# CITY OF SOLANA BEACH

## AGENDA

### Joint REGULAR Meeting

Wednesday, February 14, 2018 \* 6:00 P. M.

Figure 2: Proposed restricted access zone depicted in dotted orange line (Source: Waterford Report).

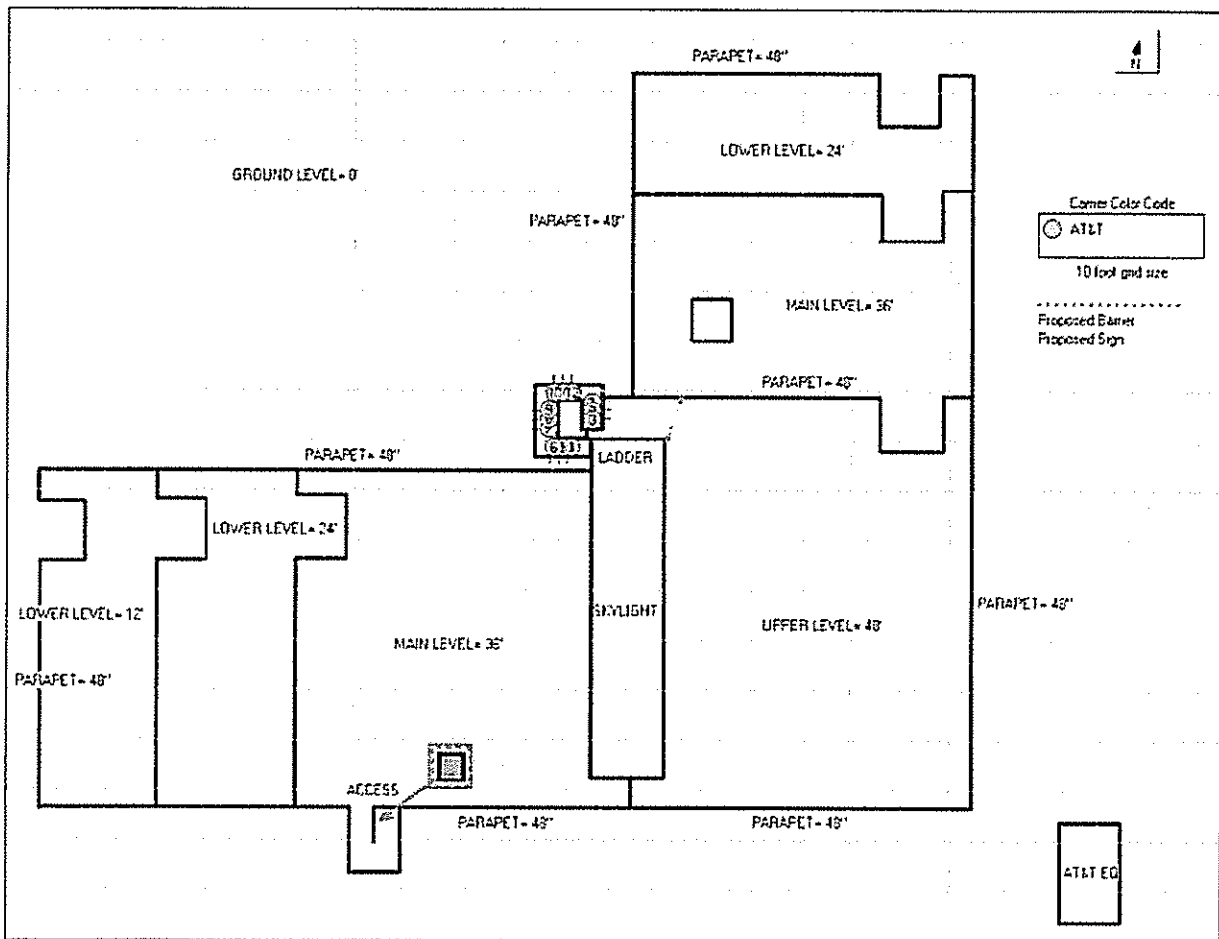
Accordingly, AT&T must take affirmative steps to post notice near, and in some cases restrict access to, the adjacent areas on the rooftop or building where the exposure exceeds the FCC's limits. Consistent with the Waterford Report, the City should require AT&T to erect a barrier and place signage on a portion of the upper level rooftop, as depicted below in Figure 3. However, in contrast to the recommendation in the Waterford Report, the City should require a larger restricted access area to encompass the entire controlled access zone. Figure 2 depicts the controlled access zone in the Waterford Report. Figure 3 depicts the boundaries of the controlled access zone as calculated by this firm based on a worst-case scenario.

## 2.2. AT&T Alternative 2: 210 Lomas Santa Fe Drive

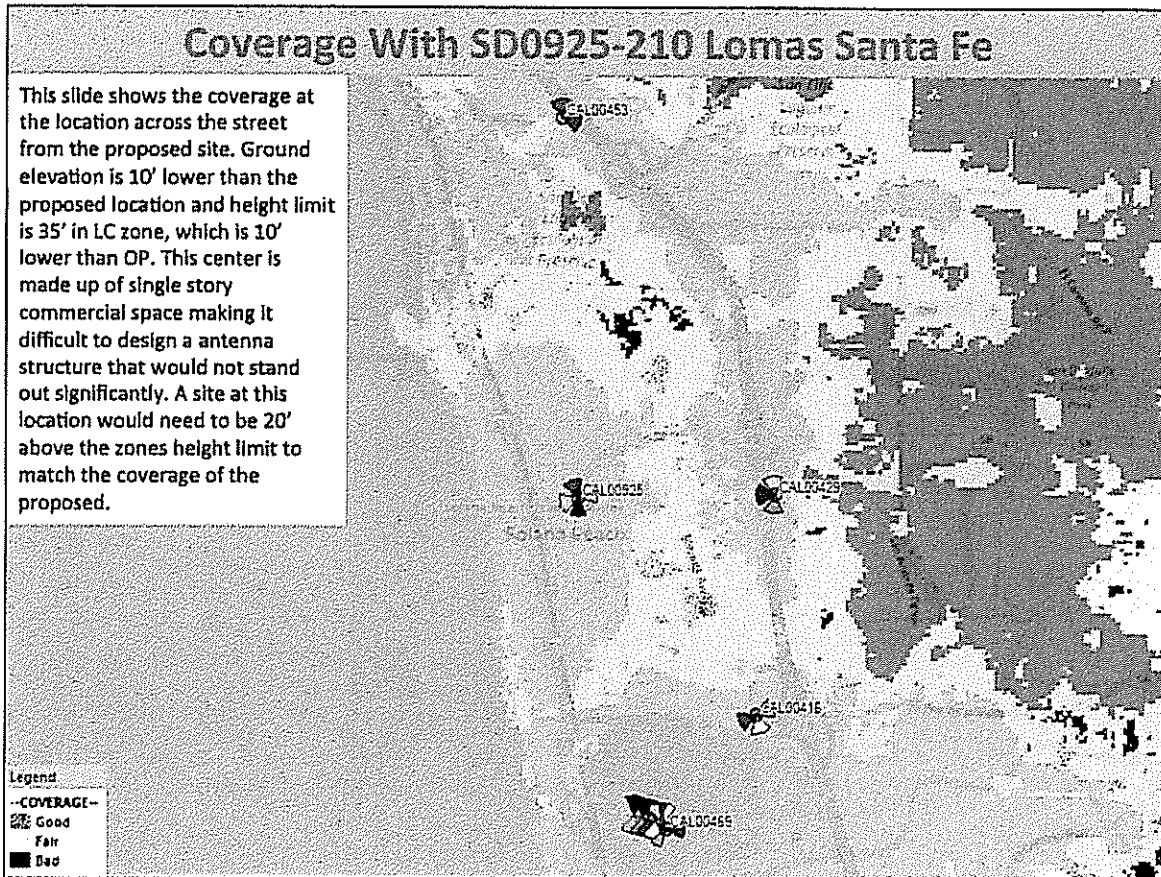
AT&T notes that this location is approximately 10 feet lower in elevation and subject to 35-foot zone height limit, which would result in an antenna centerline approximately 20

Moreover, the propagation map in **Figure 3** appears to show that the comparable coverage could be achieved without the additional 20-foot extension mentioned in AT&T's Alternatives Analysis. To be sure, the single-story, flat-roofed commercial building would present some concealment challenges. Possible designs might include, for example, a contiguous raised parapet around the entire rooftop or a freestanding architectural feature. However, even if the City ultimately prefers the design at the Proposed Location

Figure 1: Photo simulation to show possible parapet extension to screen antennas. (Source: AT&T.)

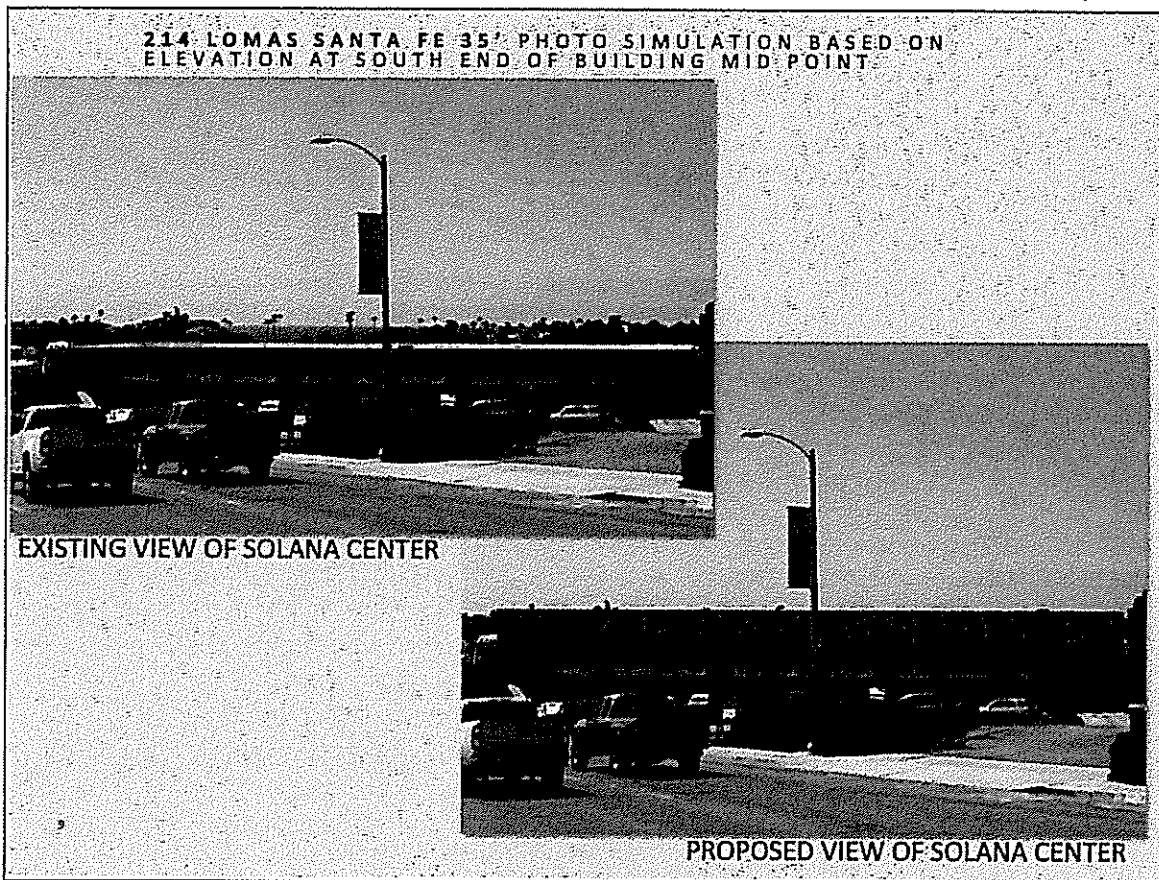
AT&T evaluated a parapet wall extension at this location and points out that this configuration would result in a more dramatic change to the building envelope as compared to the single-enclosure in its current proposal. Specifically, AT&T would have to install a parapet wall extension approximately eight feet tall around the entire perimeter of the rooftop to conceal a potential site completely. That addition would significantly displace the viewshed to the west of the property because the parapet extension would block the existing view of the beach shoreline from the east. The September Alternatives Analysis also included photo simulations to illustrate the visual impact that would result from a split-sector design, which is reproduced in Figure 1.

Figure 2: Coverage map to show predicted service from Solana Beach Presbyterian Church. (Source: AT&T.)

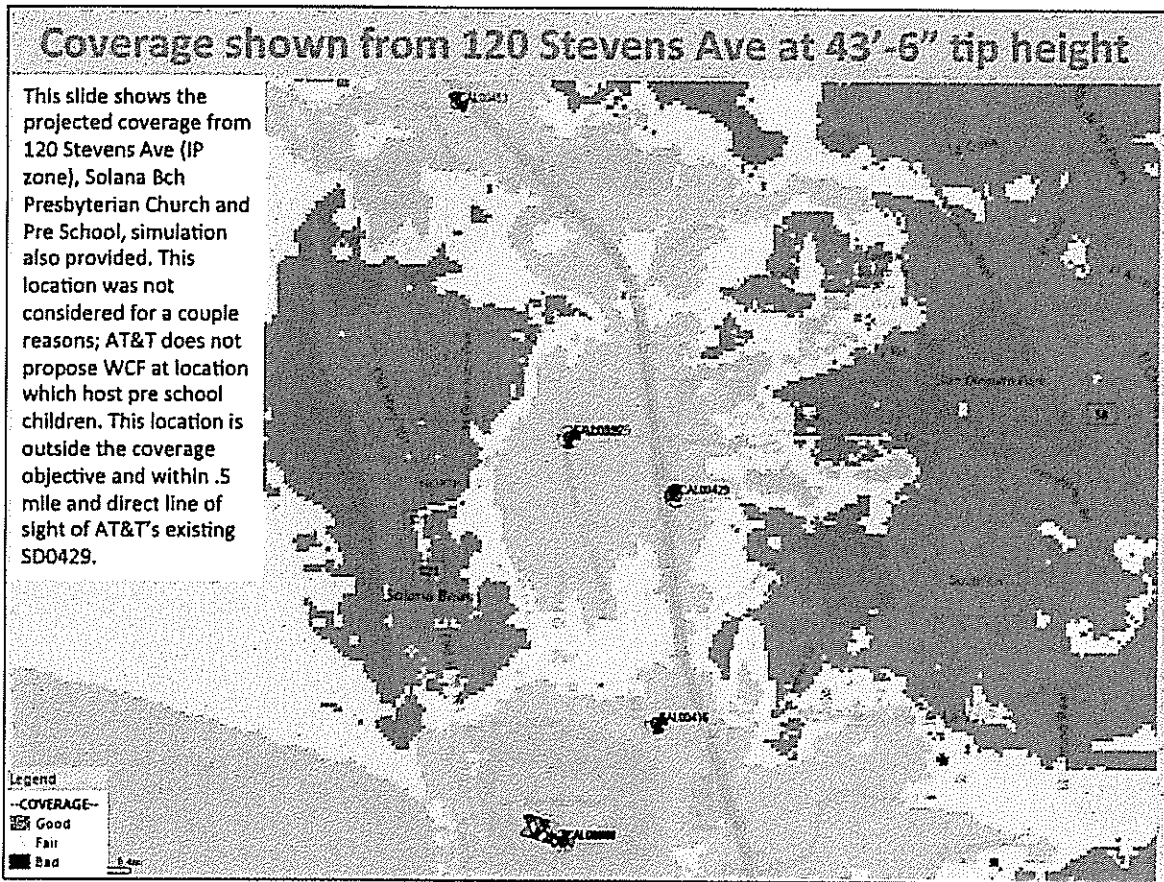
The Solana Beach Presbyterian Church appears to be technically feasible as a supplement to either Alternative Nos. 3 or 4. AT&T "[a] simulation of the best location to cover the apex of Lomas Santa Fe to the west is provided in the coverage map package." The coverage map mentioned in the quoted text above appears in Figure 2.

Upon review, a proposed site at the Solana Beach Presbyterian Church would not be technically feasible as a stand-alone site but may be a potentially feasible supplement to Alternative Nos. 3 or 4. A site at this location would not be technically feasible as a stand-alone site because it would not be able to achieve the coverage objective to the west. Although the site on its own cannot reach areas to the west, which are shaded due to the rise in elevation, it could be a technically feasible multi-site solution with Alternatives Nos. 3 or 4. Predicted service levels for a site at this location drop off fairly sharply west of South Nardo Avenue. However, a side-by-side comparison shows that the combined coverage would reach all areas in AT&T's search ring. Accordingly, the Solana Beach Presbyterian Church appears to be a technically feasible alternative under a multi-site solution.
